TECHNICAL BULLETIN

MODEL/DERIVATIVE:
Range Rover

Bulletin N°: **0012**
CDS. ref: **L8483bu**
Issue: **1**
Date: **02.06.99**

PROBLEM:
ELECTRONIC AIR SUSPENSION (EAS) NOISE - COMPRESSOR MOUNTS

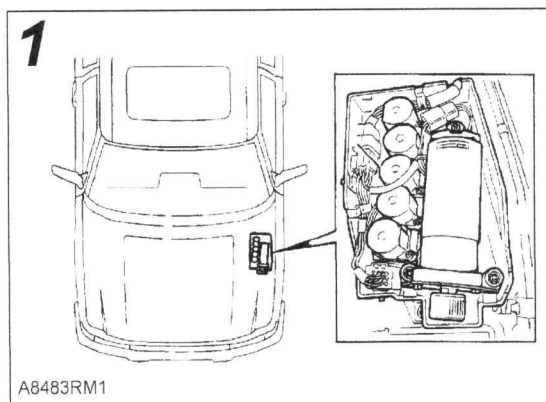
Reports of a droning noise transmitted into vehicle. The noise is apparent in the region of the front left hand corner of the vehicle and on investigation is found to originate from the air supply unit (illustration 1).

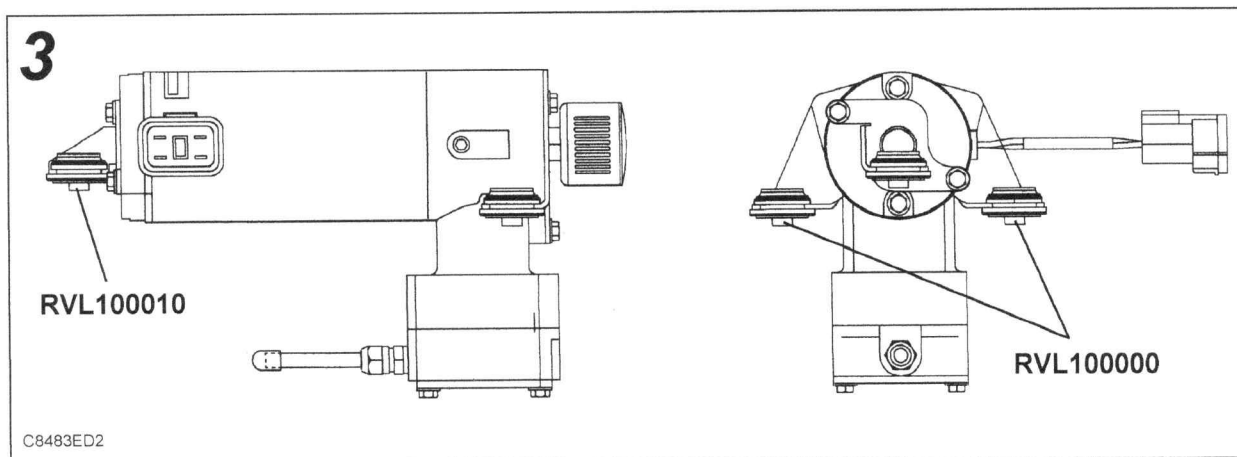
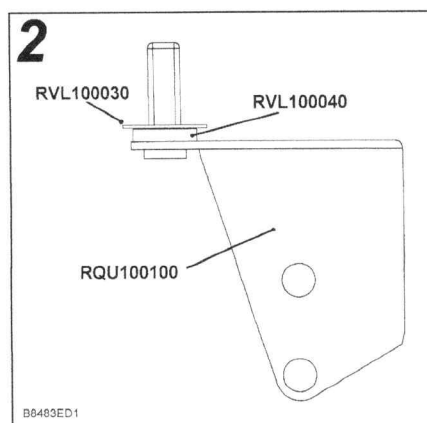
3. Referring to illustration 2, fit nylon spacer RVL100040 to bracket stud then fit flat washer RVL100030 on top of nylon spacer.
4. Remove the 2 lower front dished washers from their location in the distribution box and replace with new flat washers RVL100030.
5. Push out the 3 old mounts from the compressor assembly. Replace the 2 front mounts with new parts RVL100000 and the single rear mount with RVL100010, ensure they are fitted in the correct orientation (see illustration 3).

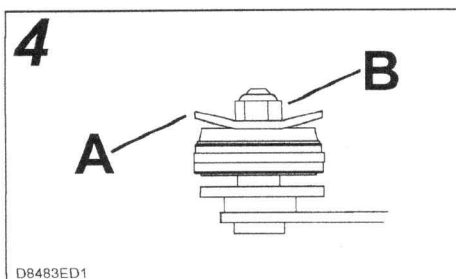
6. Refit the compressor as described in the Workshop Manual, repair number 60.50.10, ensuring that the compressor mounts are located centrally on the studs. Referring to illustration 4, refit the original dished washers 'A' and nuts 'B' to each mount, ensuring orientation is as shown. Tighten fixing nuts to 2 Nm maximum. **IMPORTANT** - do not over-tighten fixings since this will damage the new mounts.
